**Addendum No. 001**

**Subject: 2020 Classroom Modernizations**  
**SDP Contract Numbers: B-028 C of 19/20 & B-030 C of 19/20**

**Location: Overbrook Educational Center**  
**6722 Lansdowne Ave, Philadelphia PA 19151**

**This Addendum, dated March 6, 2020, shall modify and become part of the Contract Documents for the work of this project. Any items not mentioned herein, or affected by, shall be performed strictly in accordance with the original documents.**

1 OVERALL FIRST FLOOR DEMOLITION PLAN  
D1.1  
1/8" = 1'-0"

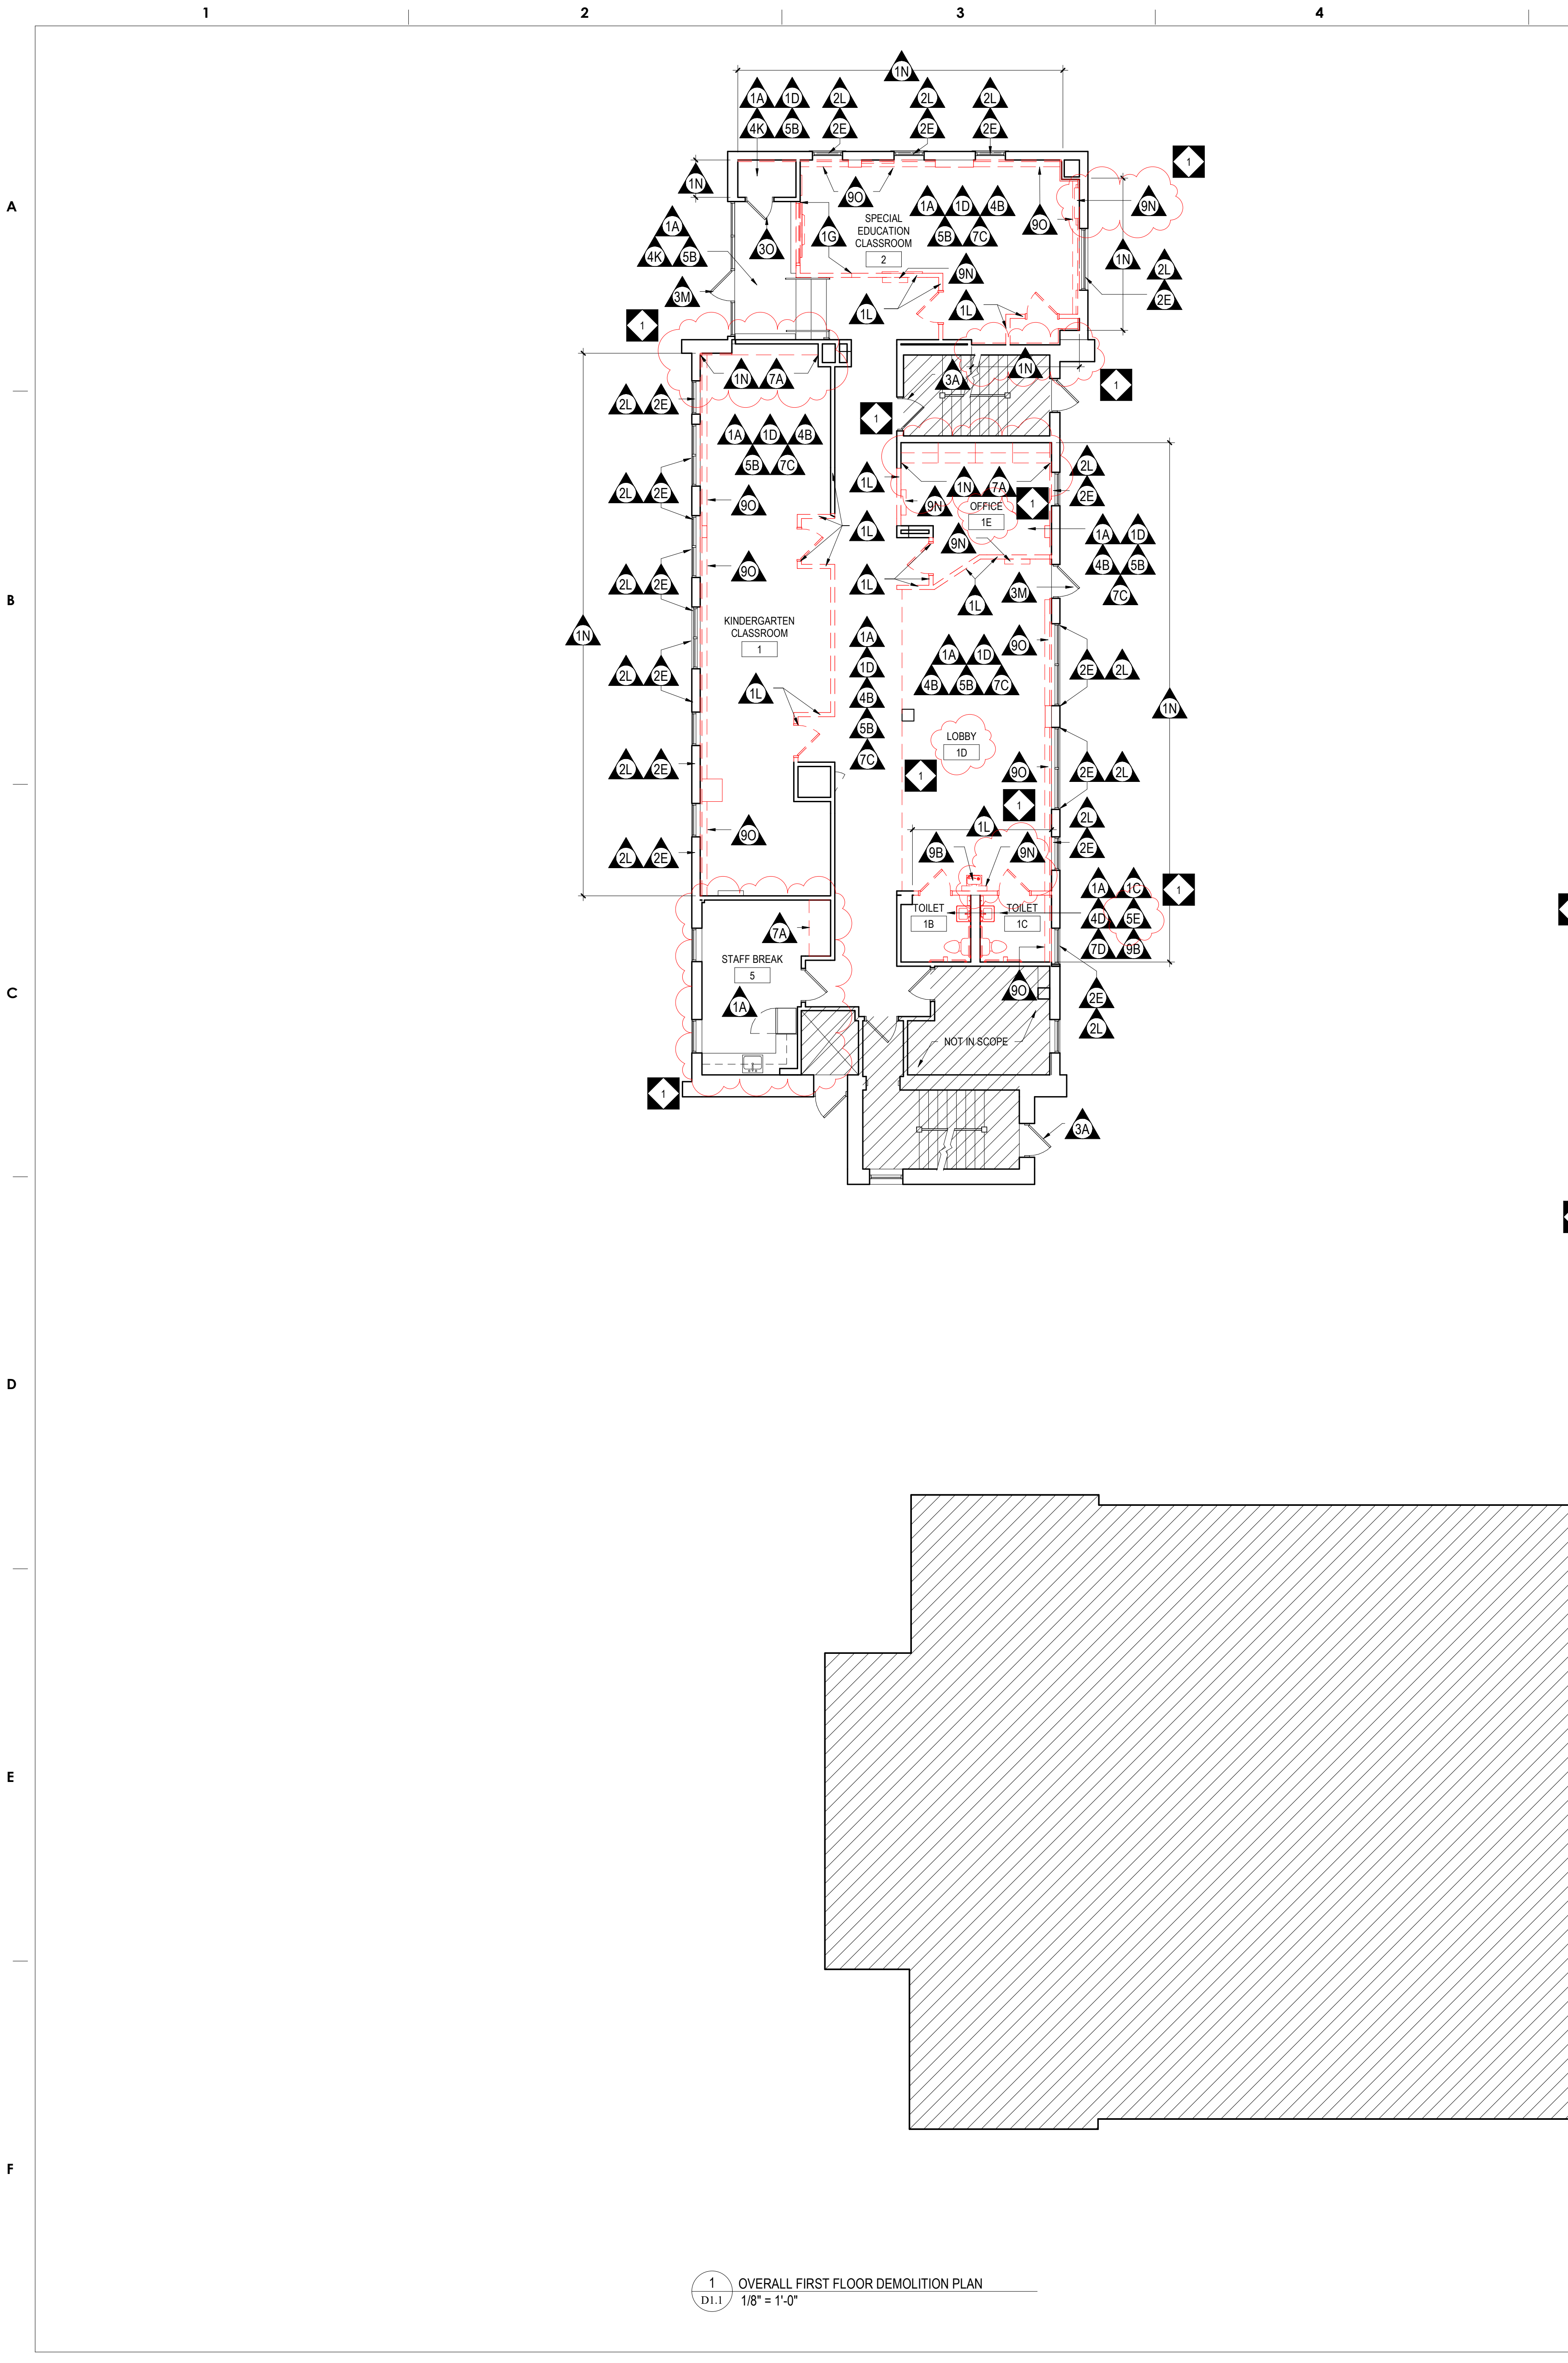
1. ADD demolition note 5E as indicated on the drawings.
2. ADD demolition note 7A as indicated on the drawings.
3. REVISE plan 1/D1.1 to include additional demolition scope as indicated on the drawings.
4. ADD Staff Break Rm 5 to scope.
5. ADD existing room tag “Lobby-1D” and “Office-1E”.
6. ADD existing mini-split to receive new work in Lobby-1D and Special Education Classroom-2.
7. REVISED demolition note 9N as indicated on drawings.

1 OVERALL SECOND FLOOR DEMOLITION PLAN  
D1.2 1/8" = 1'-0"

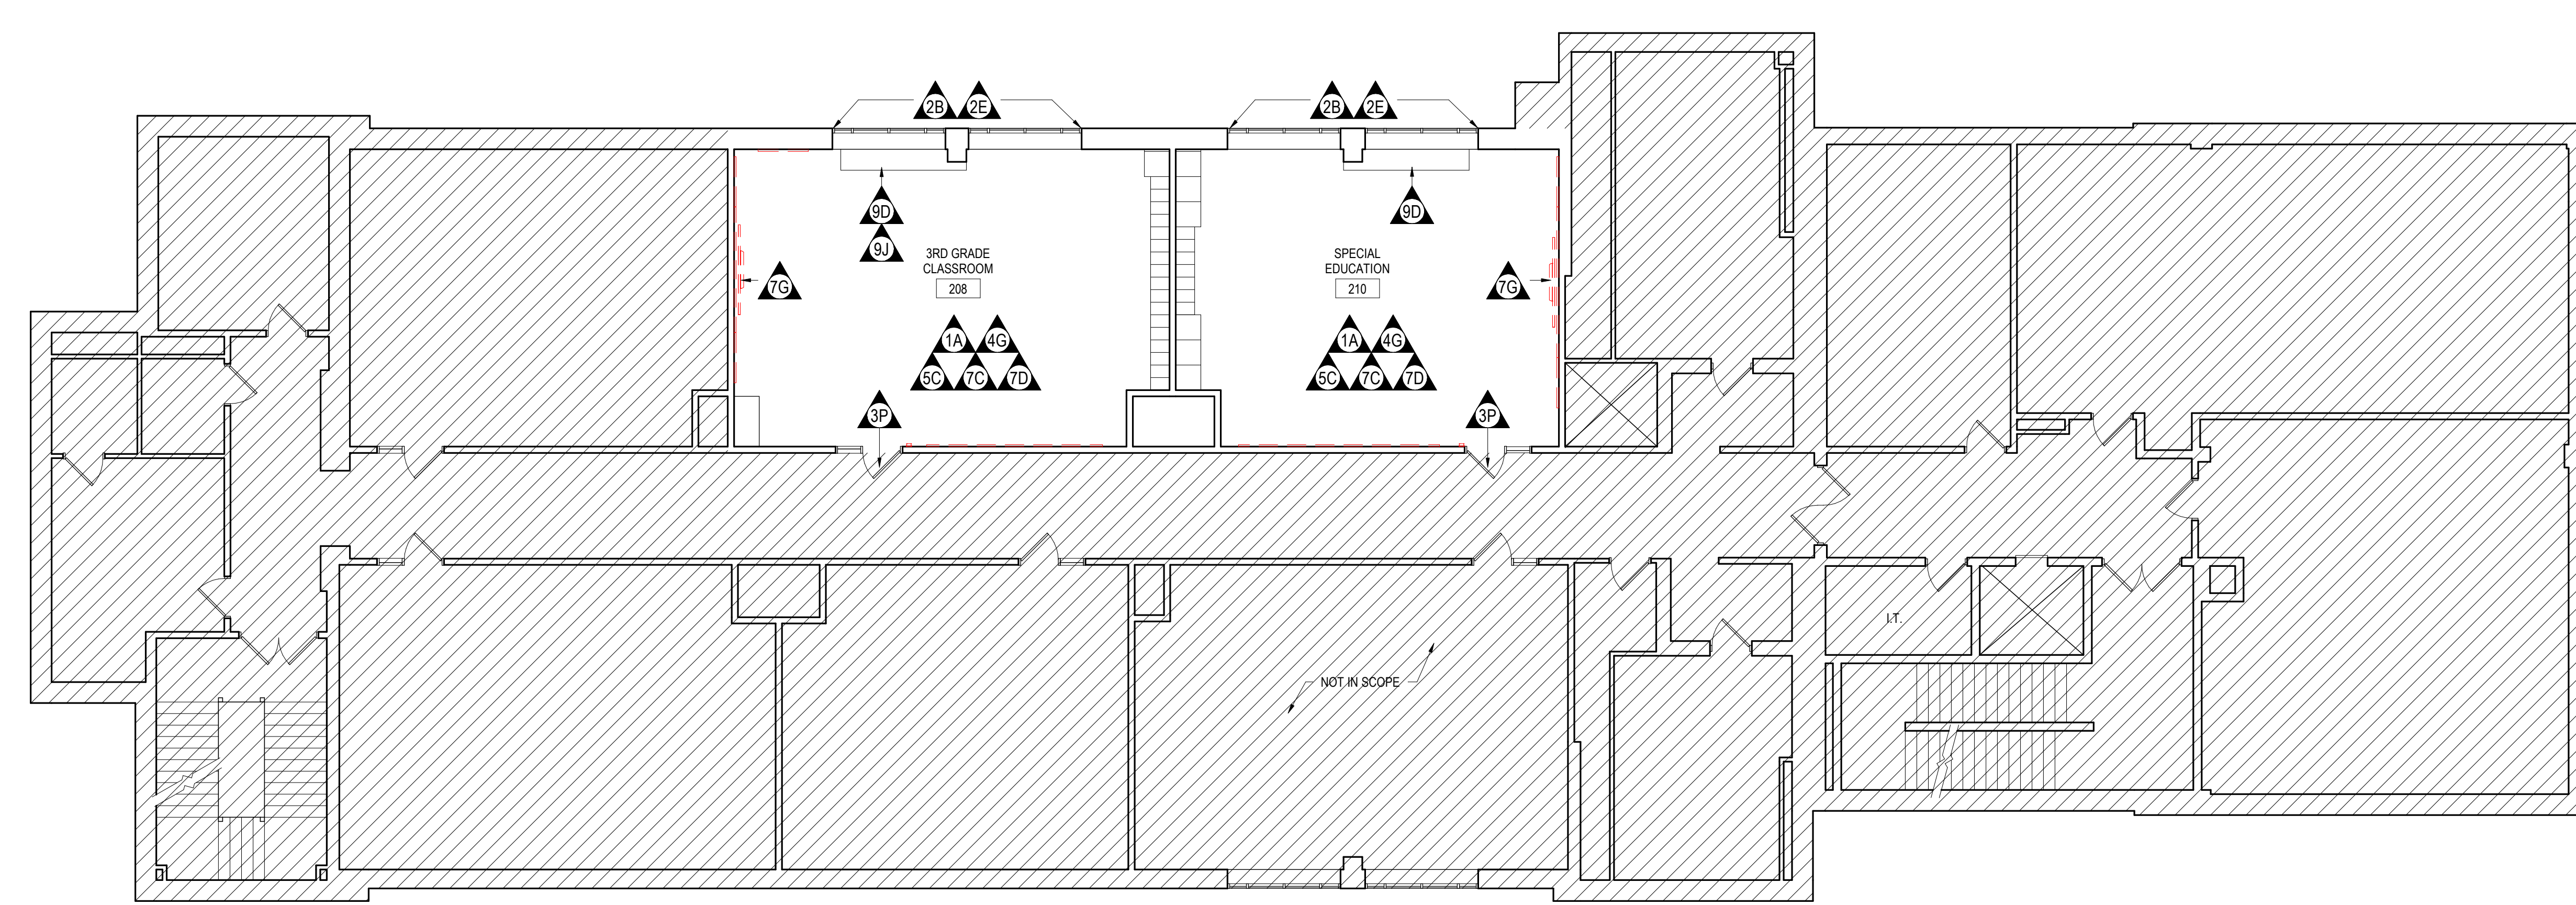
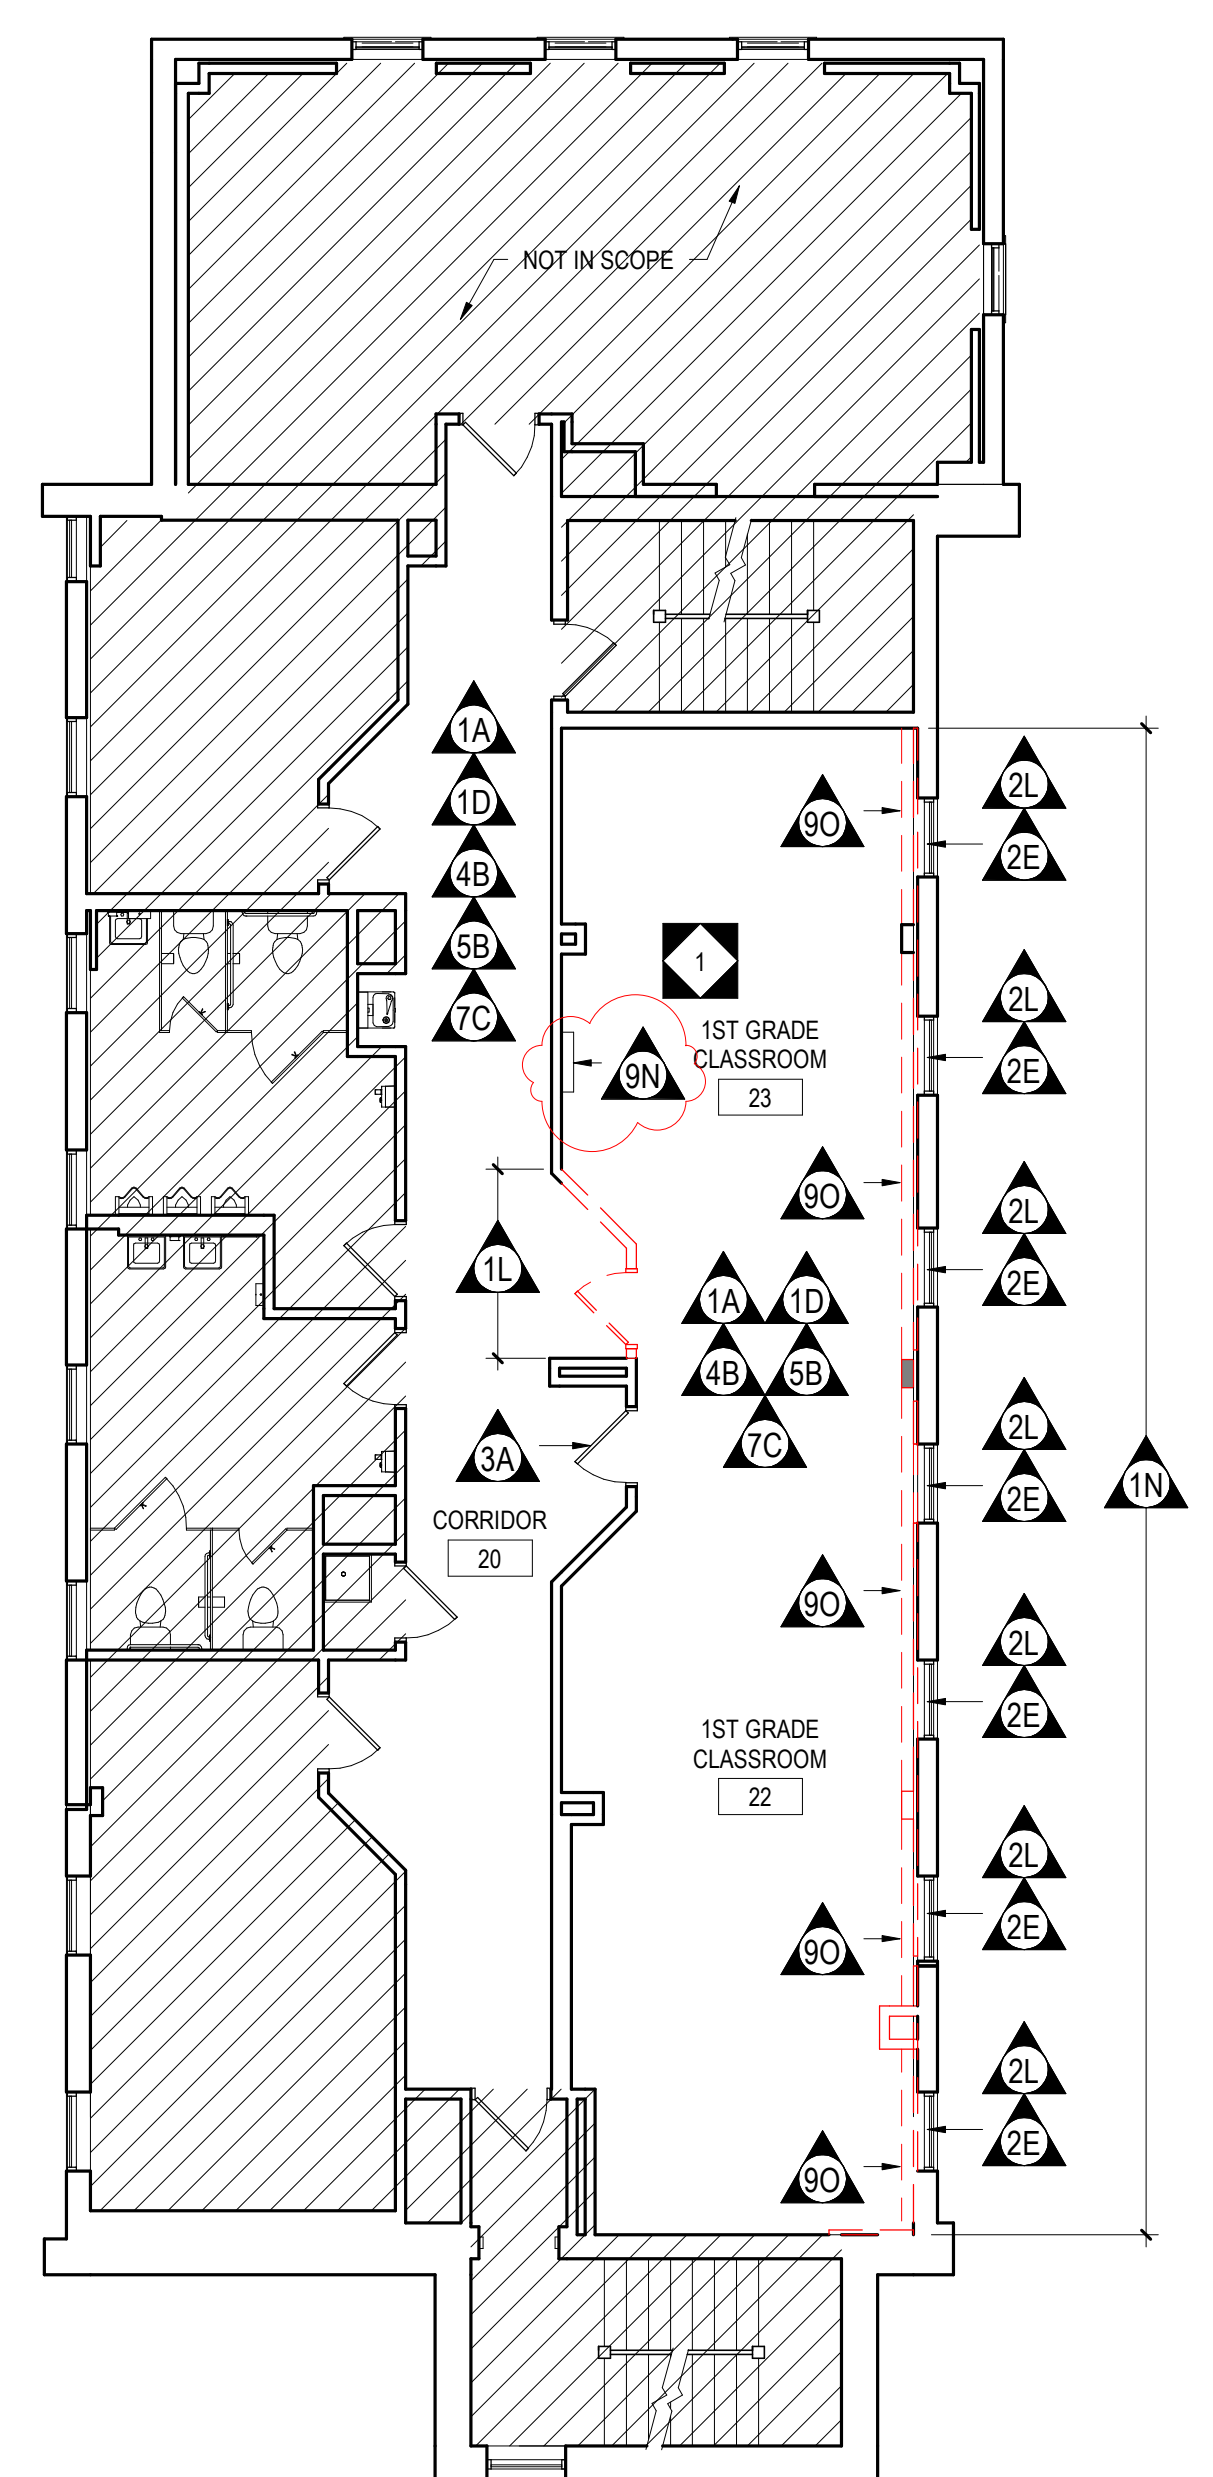
1. ADD existing mini-split to receive new work in 1<sup>st</sup> Grade Classroom-23.
2. REVISED demolition note 9N as indicated on drawings.
